DISCUSSION OF THE APPLICANT'S POSITION
ON THE NEED FOR ADDITIONAL BORINGS
FOR
MIDLAND PLANT UNITS 1 AND 2
CONSUMERS POWER COMPANY
DOCKET NUMBERS 50-329 AND 50-330

Report Date: September 14, 1980

DISCUSSION OF THE APPLICANT'S POSITION ON THE
NEED FOR ADDITIONAL BORINGS

Figure 3
(See Reference 1)

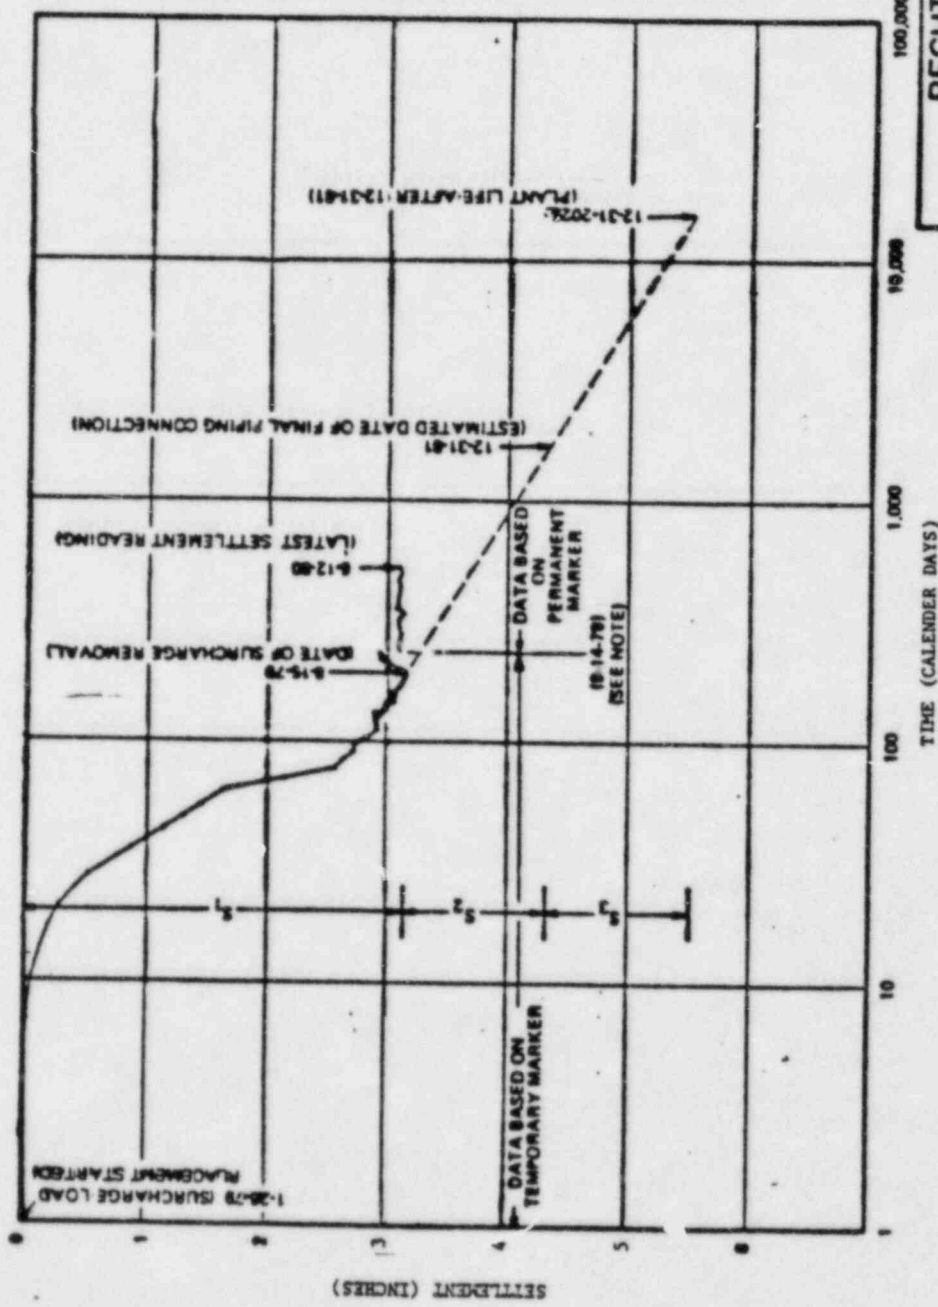
Primary settlement occurred rapidly and settlement measurements indicated secondary consolidation was occurring as verified by the straight line on the semi-log plot shown on Figure 3. This figure is typical of all the settlement curves shown in Figures 27-6 and 27-51 through 27-78 which exhibit a straight line settlement

Figure 4
(See Reference 1)

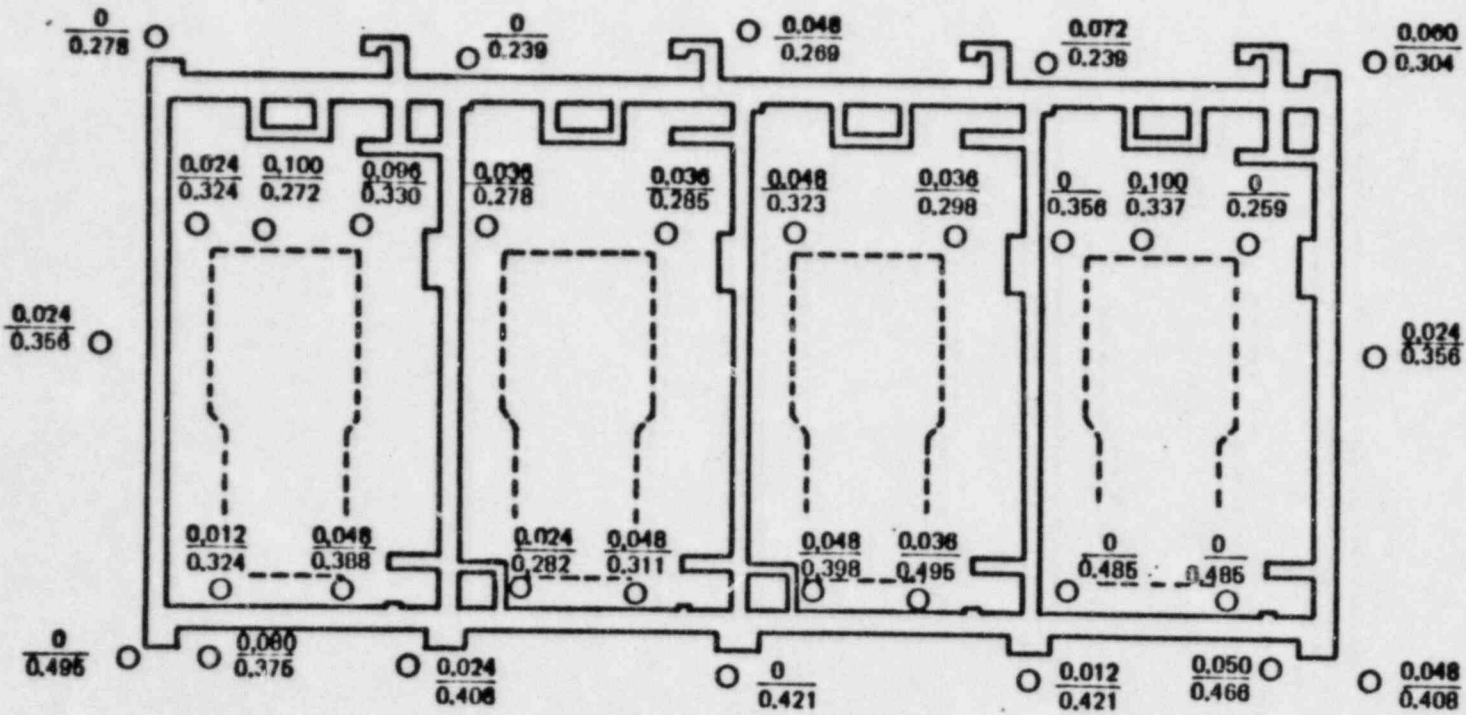
during secondary consolidation. This behavior has been recorded on many projects including the Chicago Auditorium where this straight line secondary behavior has been observed for 60 years. Settlement trends based on rates experienced while the surcharge was in place were extrapolated to predict maximum settlements expected to occur over the life of the plant. This prediction is based on the conservative assumption that surcharge loading conditions remain for the life of the structure. Settlement measurements made during the period between September 14, 1979, and June 12, 1980, show that, on the average, the building experienced less than 0.1 inch of settlement as shown on Figure 4.^(4,7,8)
